Remarks

Objection to the Specification

Objections to the Drawings

Figure 3

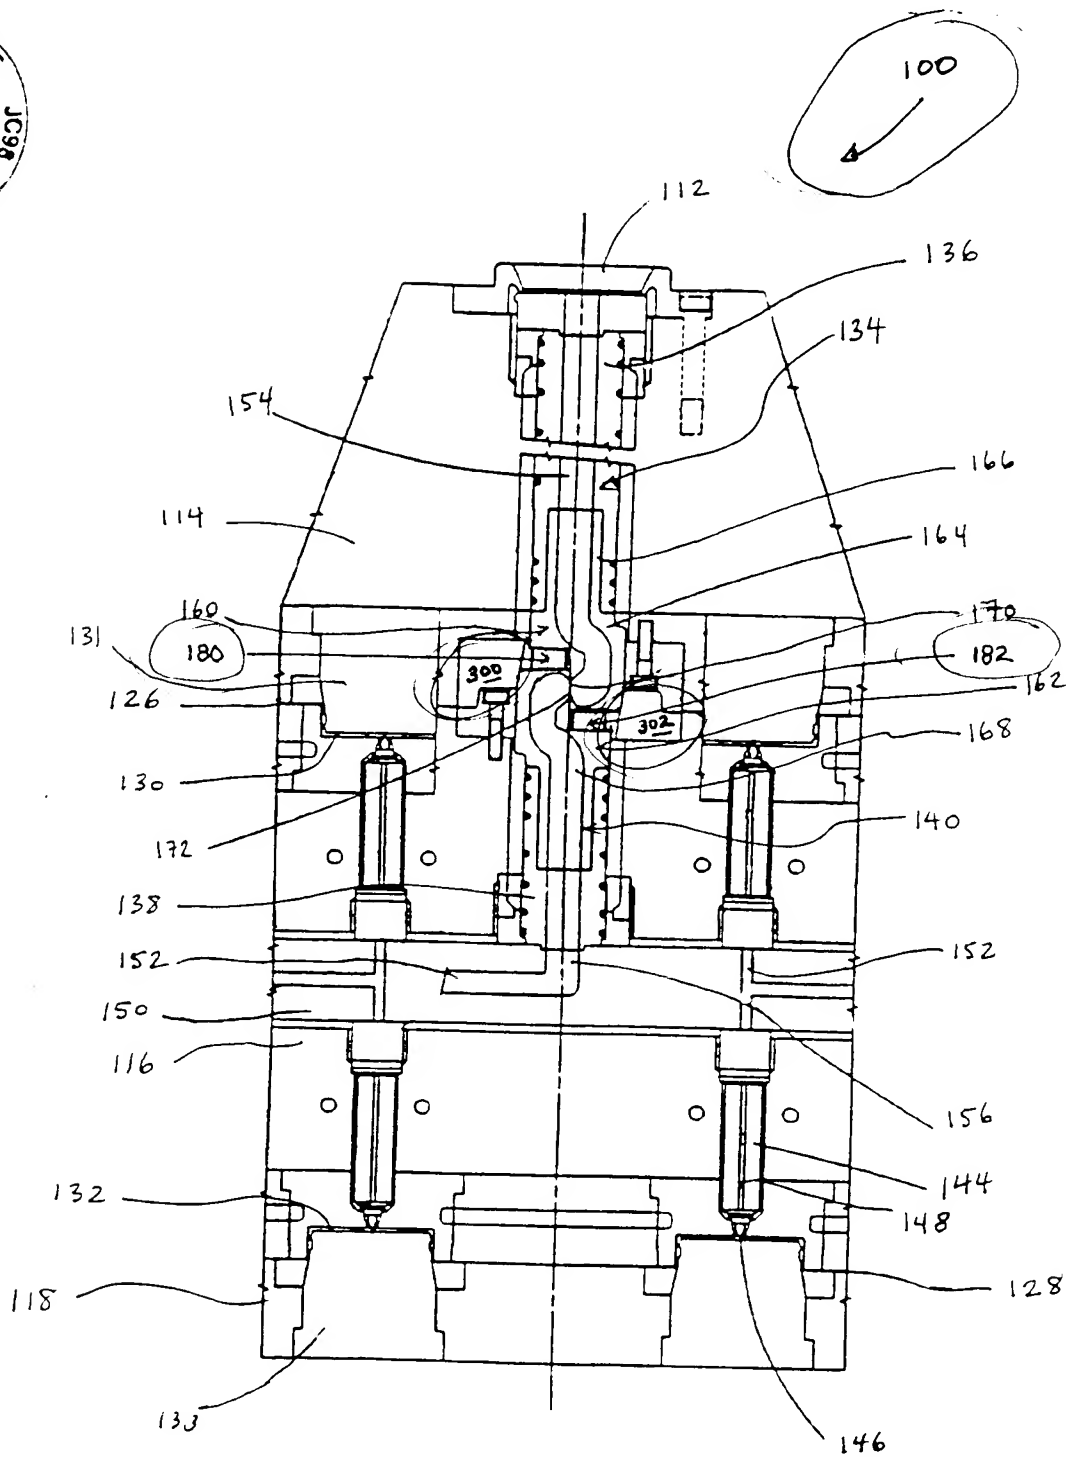
The Examiner objected to the drawings because they failed to comply with 37 C.F.R. 1.84(p)(5) for not including the reference number "100" that was mentioned in the specification in paragraph 023. Applicant submits herewith replacement figures 3-8 correcting this error and addressing other inconsistencies found during a review of the

drawings. Six (6) sheets of Replacement Drawings and six (6) sheets of Annotated Drawings Showing Changes are submitted herewith. No new matter has been added by these amendments and support for these amendments is found throughout the specification.
